REMARKS

This reply is in response to the Final Office Action dated November 18, 2009. Claims 58-62, 64, 65, and 73-85 are pending in the application and stand rejected.

Figure 2H

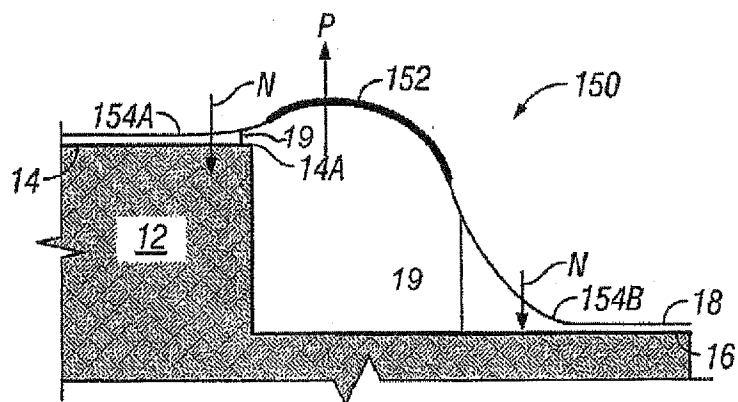
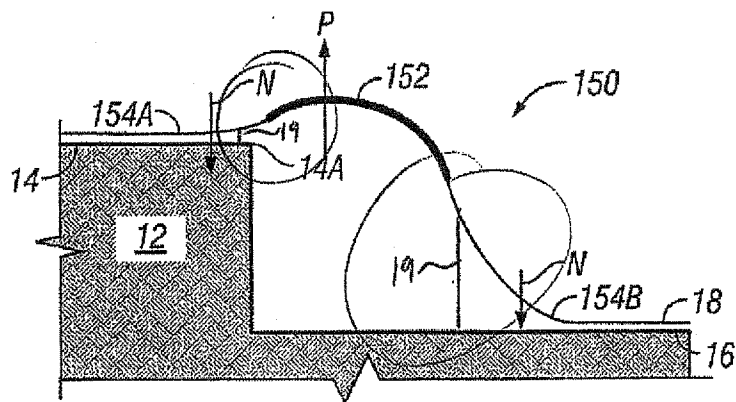
Applicant has amended Figures 2H and 2I to properly identify the tethers 19. No new matter has been added.
